EXPEDITED MONTGOMERY COUNTY HISTORIC PRESERVATION COMMISSION STAFF REPORT							
Address:	8200 Meadowbrook Ln., Chevy Chase	Meeting Date:	1/27/2021				
Resource:	Individually Listed Master Plan Resource Rock Creek Stables, Master Plan Site # 36/003-	Report Date: 000A	1/20/2021				
Applicant:	Montgomery Parks	Public Notice:	1/13/2021				
Review:	HAWP	Tax Credit:	n/a				
Permit No.:	936758	Staff:	Dan Bruechert				
Proposal:	ADA Restroom Alterations and Hardscape

PROPOSAL

Image #4: Proposed Condition outside the restrooms

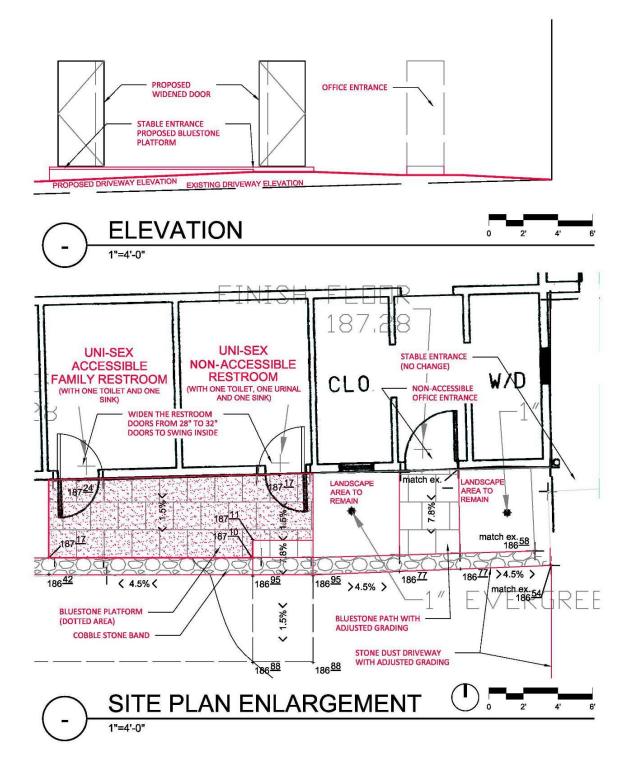
The proposed work will install a larger bluestone landing, regrade and re-pave the area around the bathroom entrances, and install new, wider doors. The overall visual impact of the proposed work on the historic appearance of the stable building is limited and will not detract from the historic character. Staff Recommends the HPC approve the HAWP.

Staff recommends that the Commission **approve** the HAWP application under the Criteria for Issuance in Chapter 24A-8(b)(1) and (2), having found that the proposal will not substantially alter the exterior features of the historic resource and is compatible in character with the district and the purposes of Chapter 24A;
